September 10, 2015

G0058

SUBJECT: Update Report and Response to City Review Team Comments

RE: 1925 El Camino De La Luz, APN: 045-100-024
Santa Barbara, California

Slope Stability Analysis Results

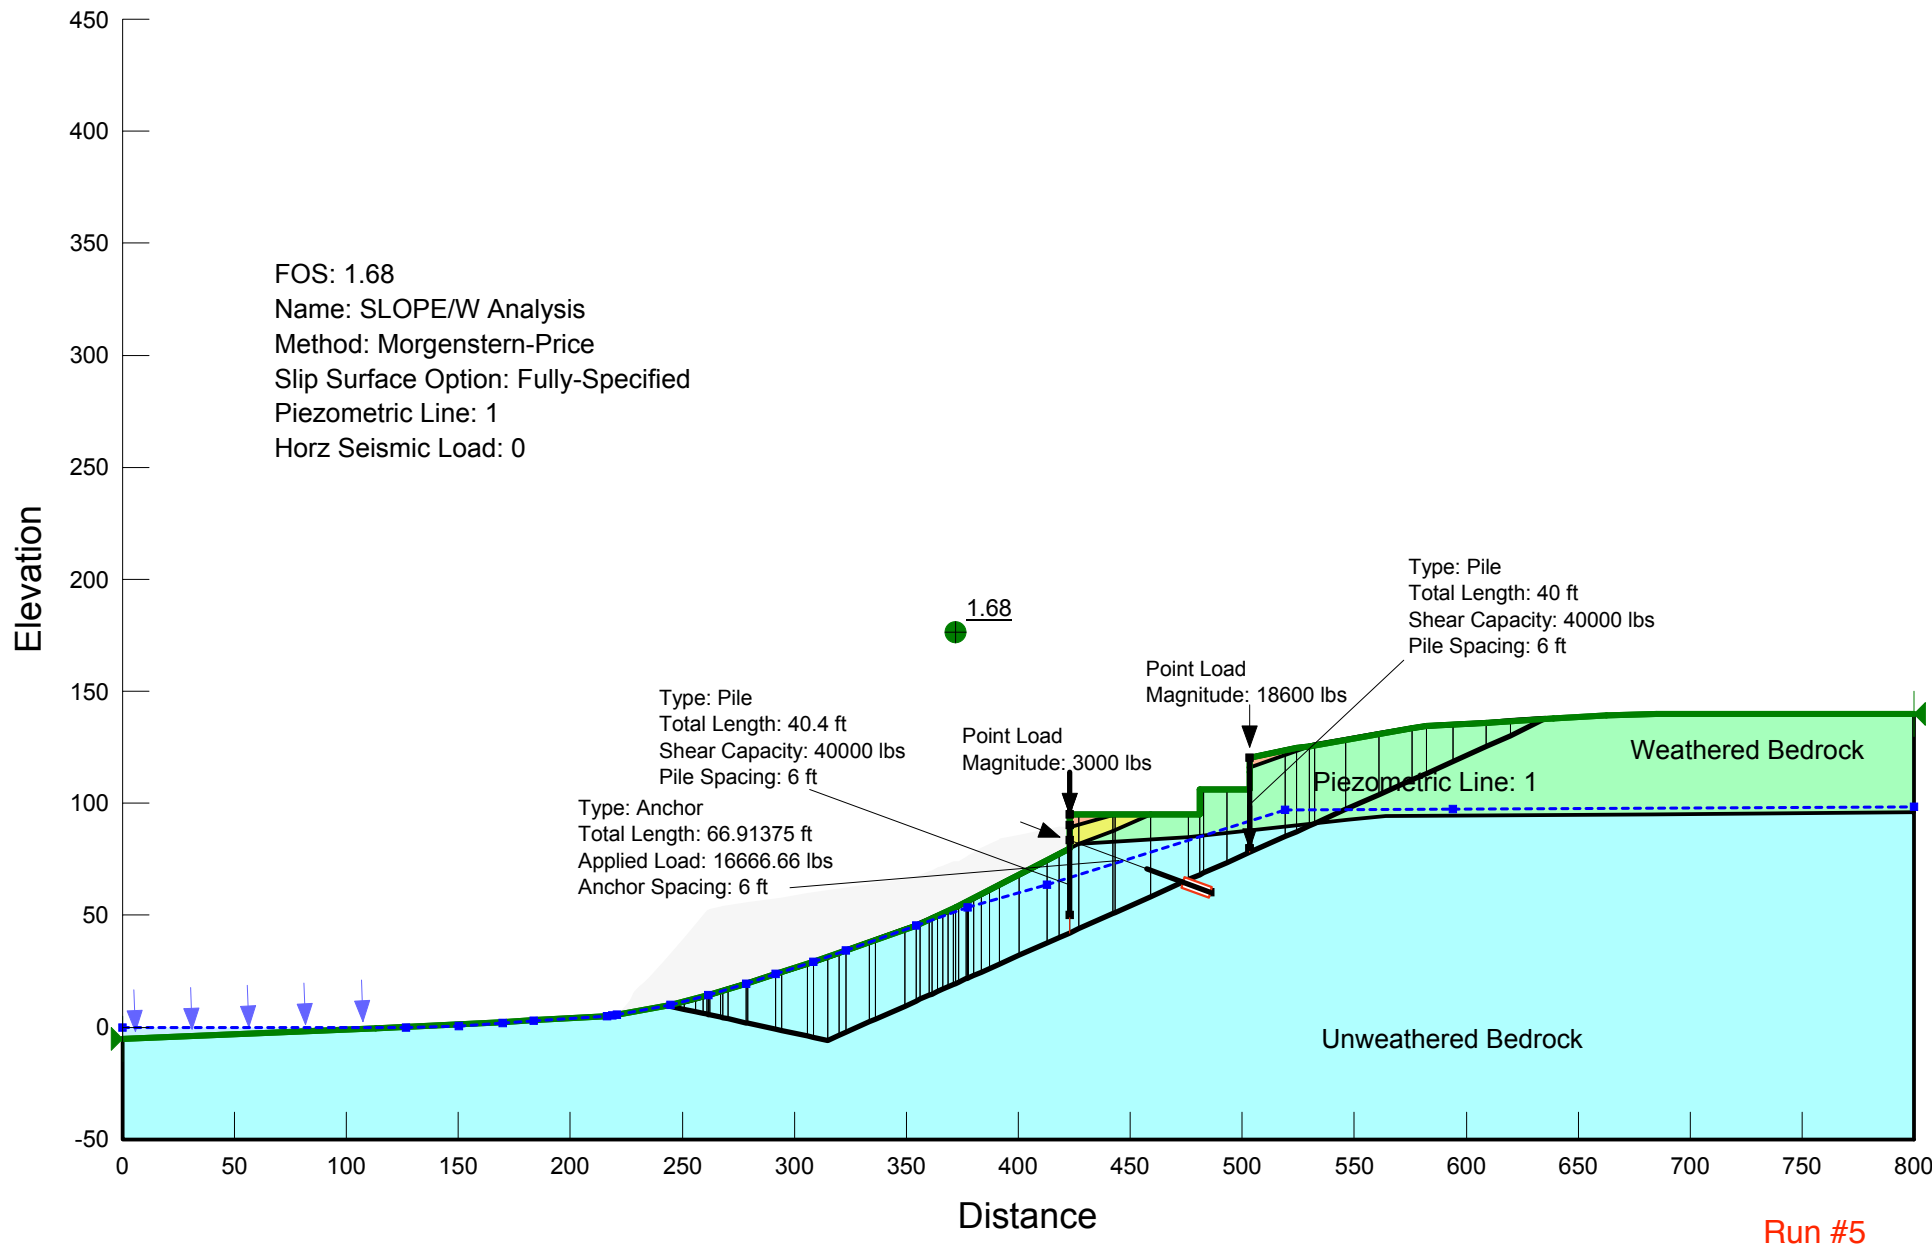
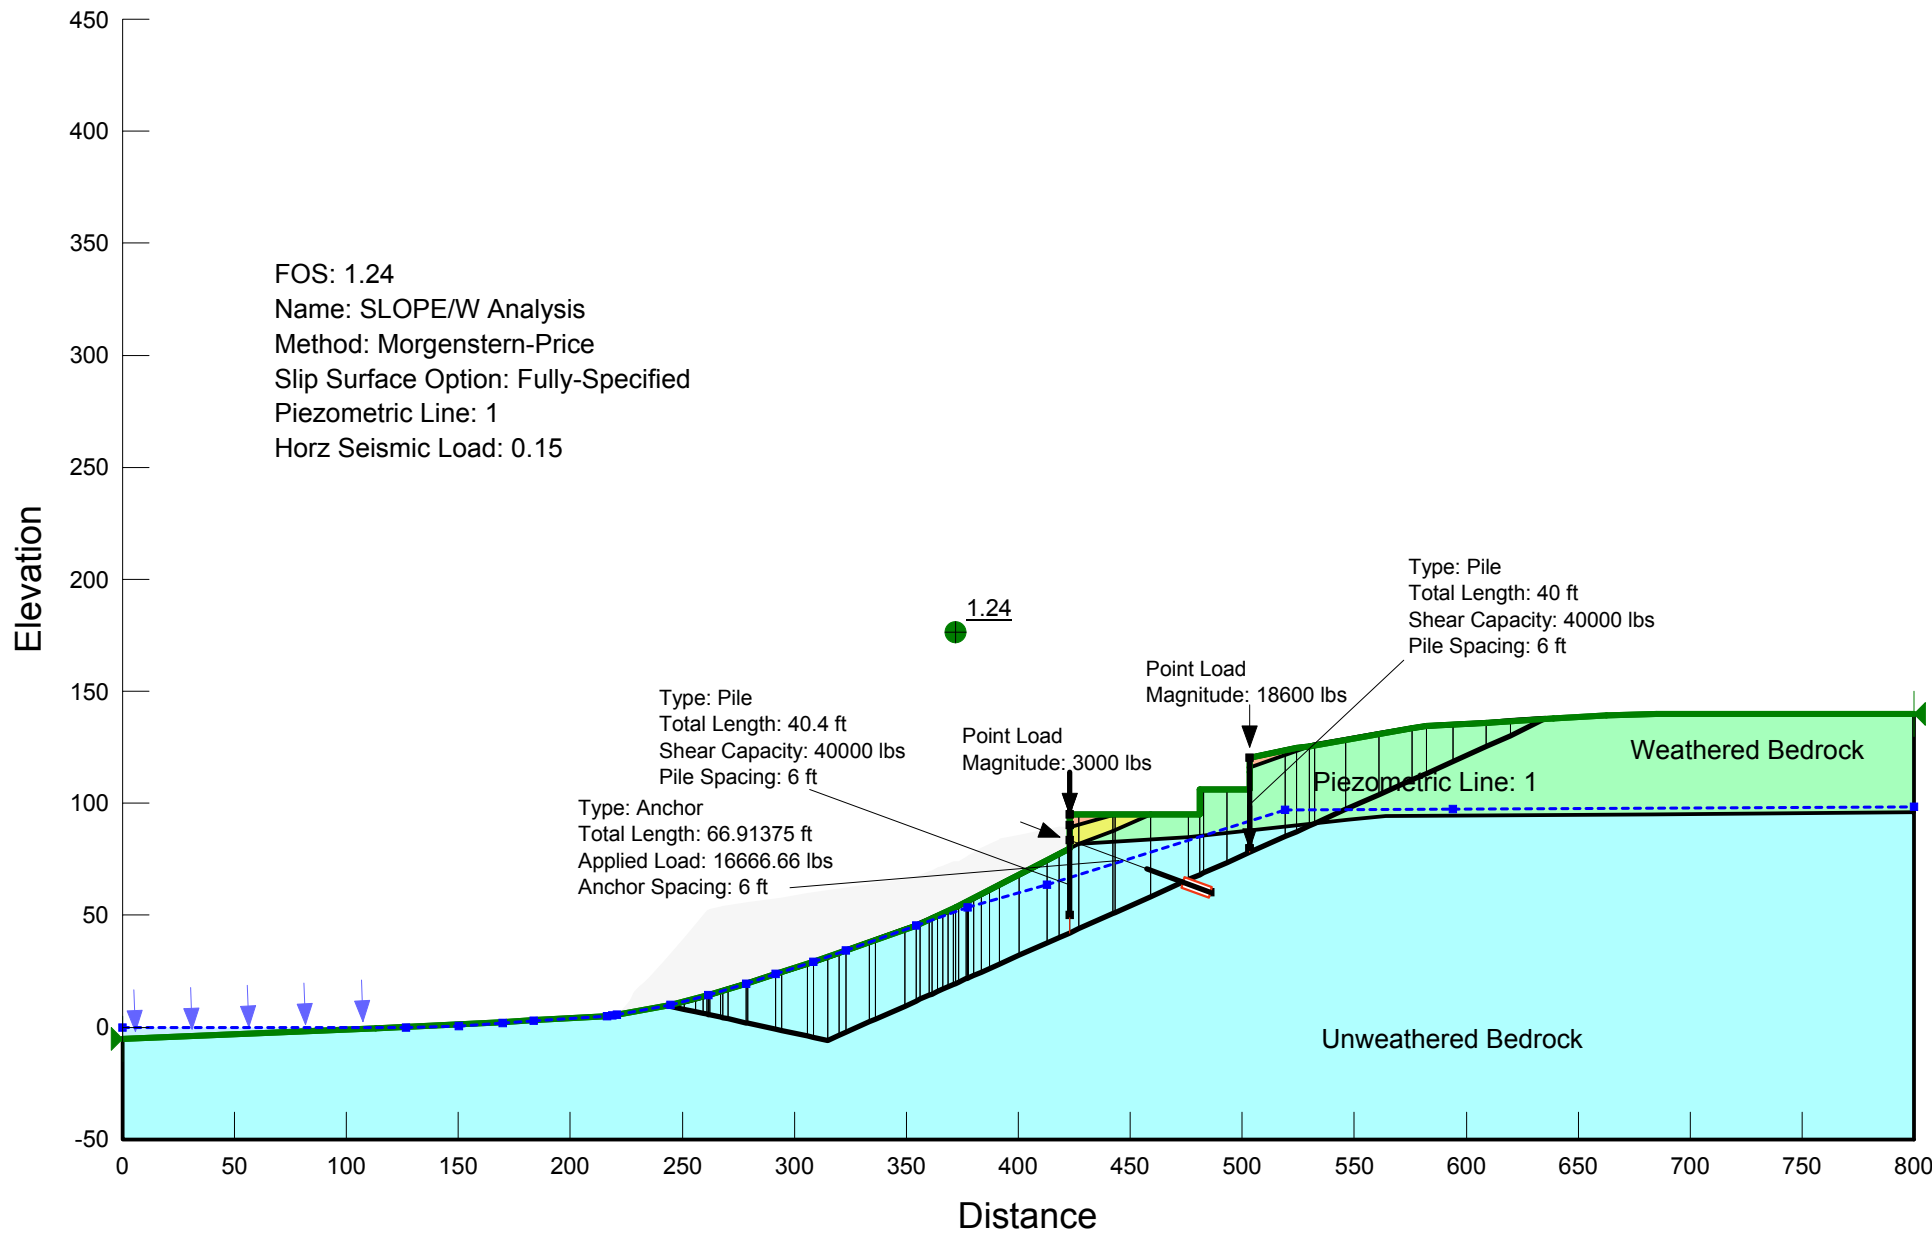
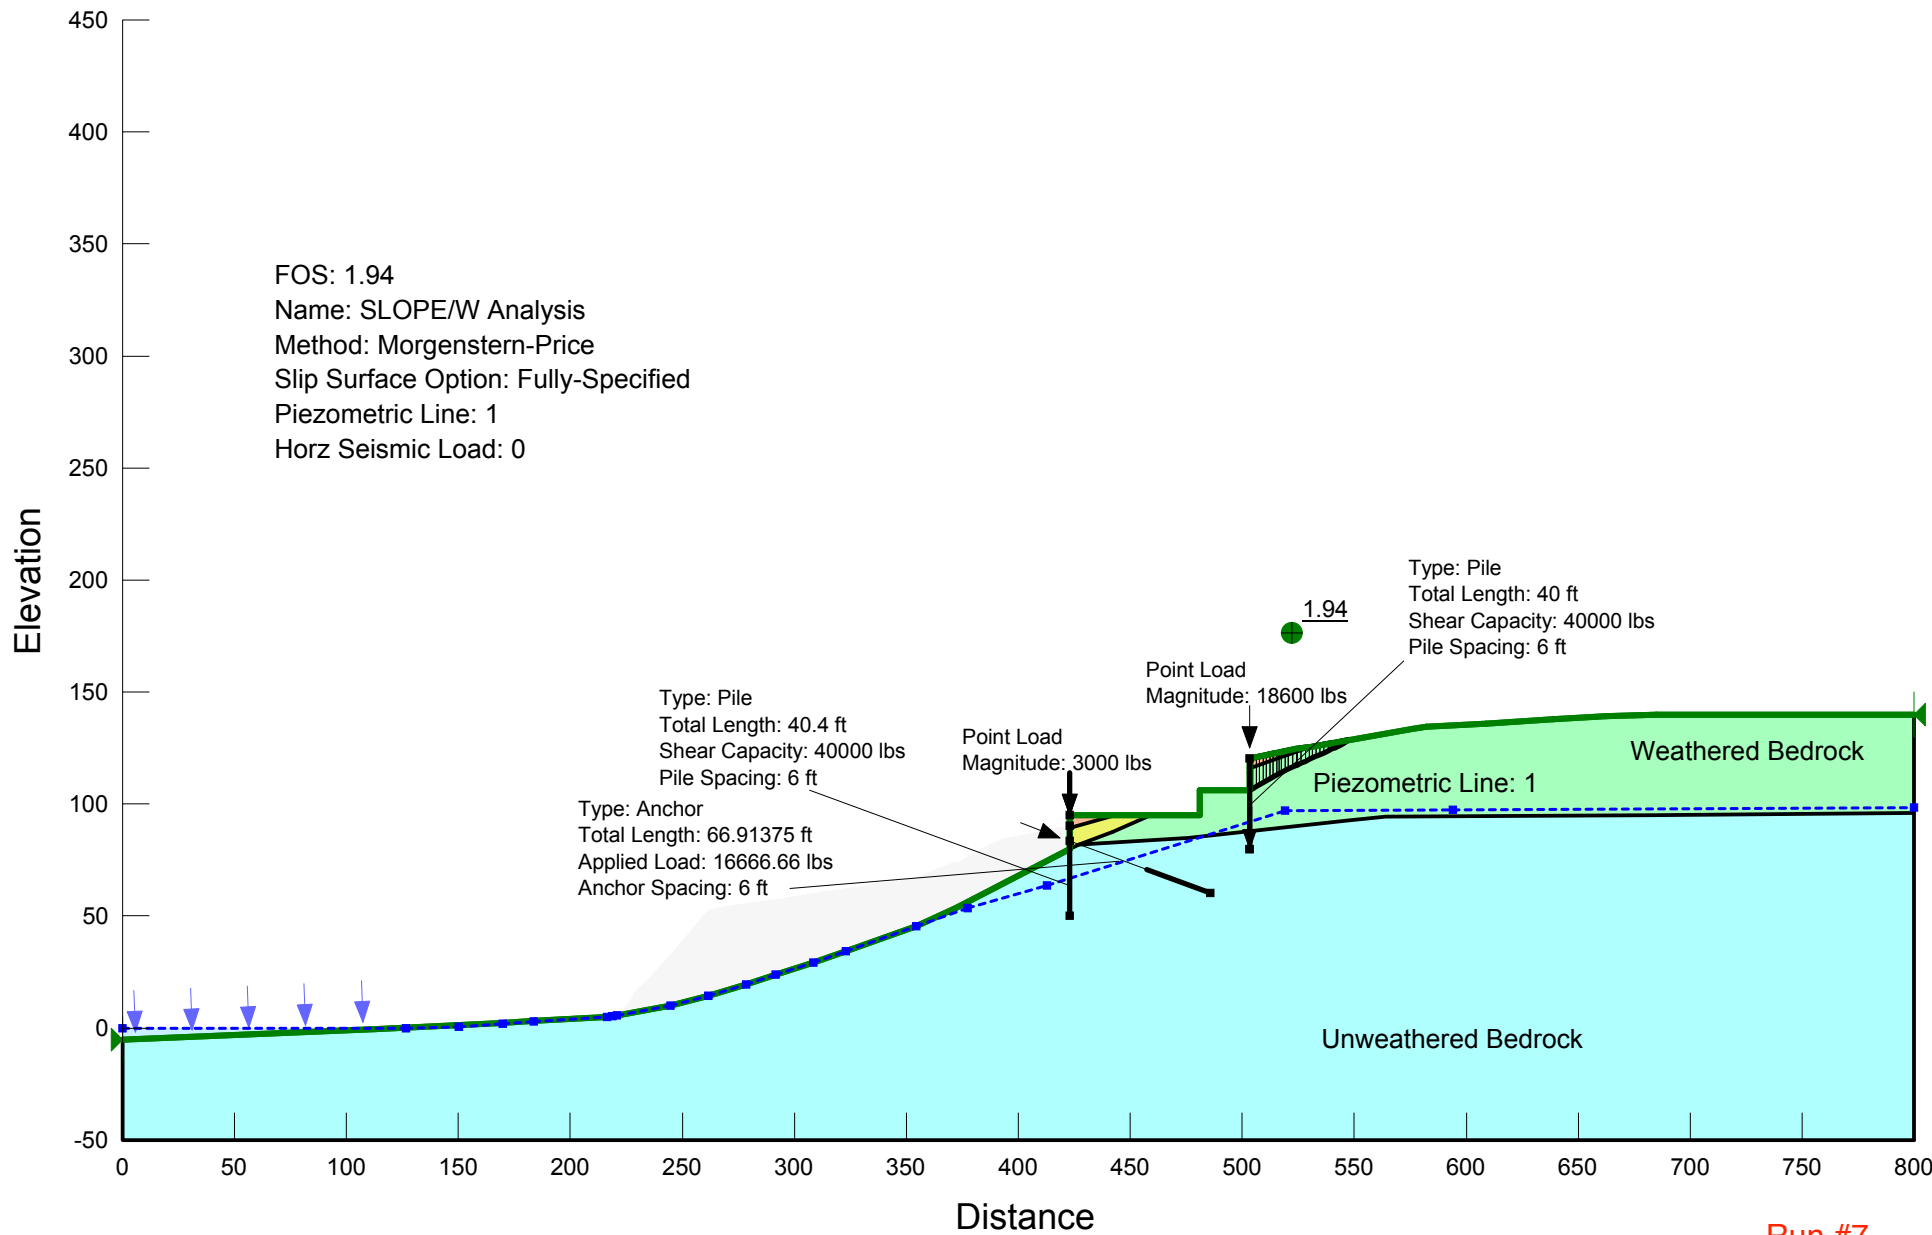
- 1. Review Comment 1: Preliminary Geologic and Geotechnical Investigation – Oct. 2012: Provide structural calculations that justify and confirm the use of the building loads specified on page 37 of this report; “We modeled the residential loads assuming two parallel contiguous point loads of 850 lbs, 20 feet apart.”*

2. *Review Comment 2: Preliminary Geologic and Geotechnical Investigation – Oct. 2012: Provide justification for the use of a base safety factor of 1.01 for the area of the landslide debris listed on page 38 of this report.*

CSA Response to Comment #1 – The preliminary point load values used to represent the proposed structures were reviewed by the Project Structural Engineer. Upon review and additional analysis, the Project Structural engineer updated the proposed building loads and recommended a point load of 3,018 pounds on the lower shear pin and a point load of 18,600 pounds on the upper shear pin (calculations included in Attachment A). Consequently, the slope stability analyses were updated to include these recommended point loads. In our October, 2012 Geologic and Geotechnical Report, a summary of the slope stability analysis results is presented in Table 3 on Page 38; Slope Stability Analysis (SSA) Run #'s 5 through #10 from this table have been re-calculated using the revised point loads. We have summarized the results of this analysis in the following table.

CSA Response – CSA utilized a factor of safety of 1.01 for the landslide debris for the purpose of back-calculating the strength of the basal rupture for forward analyses. Our slope monitoring reveals that the landslide debris is not moving, and thus, must contain a minimum factor of safety of 1.01 (and probably greater). CSA's monitoring includes periodic measurements of 2 slope inclinometers within the landslide debris, and periodic visual inspections of the landslide, neither of which show any evidence of recent movement. It is also noteworthy that Profile A-A' does not reflect grading and keyway stabilization of the western portion of the landslide, which likely has three-dimensional stabilization impacts that are not realized along the two-dimensional cross section line. In other words, the stabilization work performed in the mid-1980s along the western portion of the landslide included the excavation of a keyway below the landslide basal shear surface, and replacement with engineered fill that necessarily adds a stabilizing component to this portion of the landslide, which also likely adds a stabilization component to the entire landslide as a whole (three-dimensional effects). Consequently, while we have used $FS=1.01$ for the landslide debris, which is the minimum safety factor for a marginally stable slope, the actual factor of safety is likely greater than 1.01. Determining this FS with more specificity would entail a subsurface exploration program of all of the nearby properties containing the landslide debris to adequately characterize the actual safety factor, which was beyond the scope of our investigation.

Additional slope stability analyses were conducted on Slope Stability Section A-A' to estimate the approximate location of a potential failure surface with a Factor of Safety of 1.5. Two scenarios were considered: 1) the existing landslide in-place (current condition), and 2) the theoretical condition where the landslide is evacuated (conservatively not relied upon for any buttressing effect). The computer program,

material properties, method of analysis were the same as used previously and summarized in the October 2012 report. For the current analyses, the minimum slide surface depth was restricted to 10 feet to ignore shallow surficial potential failure surfaces and a block search method was used. The results indicate that for the landslide in-place (current conditions), the minimum Factor of Safety for the conditions analyzed was $FS = 2.16$.
